# Access Compliance Report

## Public Rights-of-Way

Intersection ID: 2834	Main Street: GLEN_MANOR_DR	Cross Street: NOBILITY_CT	Location: NW
ADA ID: 4D6441AF7434	Ramp Type: PerpDiag	Initial Pass/Fail: Fail	Overall Compliance: No
		Severity Score: 10

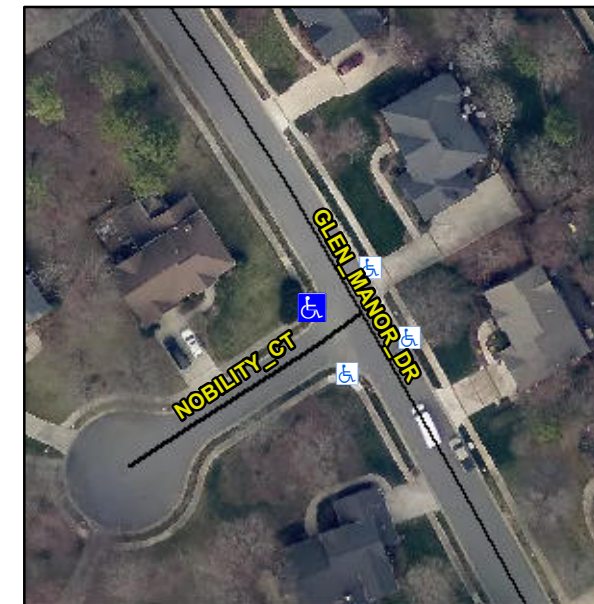
**Remove & Replace Curb Ramp With Two New Directional Ramps or Equivalent.**

**Not Found, R304.5.1, R304.5.3**

Compliance	Description	Data	Compliance	Description	Data
N/A	Ramp Length (in)	33.0	Yes	Ramp Slope (%)	5.7
No	Ramp Width (in)	43.0	No	Ramp XSlope (%)	4.1
N/A	Flare Type LT	N/A	N/A	Flare Type RT	N/A
N/A	Flare Slope LT (%)	N/A	N/A	Flare Slope RT (%)	N/A
N/A	Flare Traversable LT?	N/A	N/A	Flare Traversable RT?	N/A
N/A	Landing Length (in)	N/A	N/A	DWS Provided?	N/A
N/A	Landing Width (in)	N/A	N/A	DWS Contrast?	N/A
N/A	Landing Slope (%)	N/A	N/A	DWS Length (in)	N/A
N/A	Landing X Slope (%)	N/A	N/A	DWS Full Width?	N/A
N/A	Landing Curb? (Y/N)	N/A	N/A	DWS Offset (in)	N/A
N/A	Shared Landing?	N/A			
N/A	Gutter Ponding?	N/A	N/A	Gutter Slope (%)	N/A
N/A	Gutter Lip Ht (in)	N/A	N/A	Gutter X Slope (%)	N/A
N/A	Painted X Walk1?	No	N/A	Painted X Walk2?	No
	X Walk 1 Direction	To S		X Walk 2 Direction	To E
N/A	X Walk 1 Width (in)	N/A	N/A	X Walk 2 Width (in)	N/A
	X Walk 1 Slope (%)	0.6		X Walk 2 Slope (%)	3.4
	X Walk 1 X Slope (%)	1.1		X Walk 2 X Slope (%)	3.0
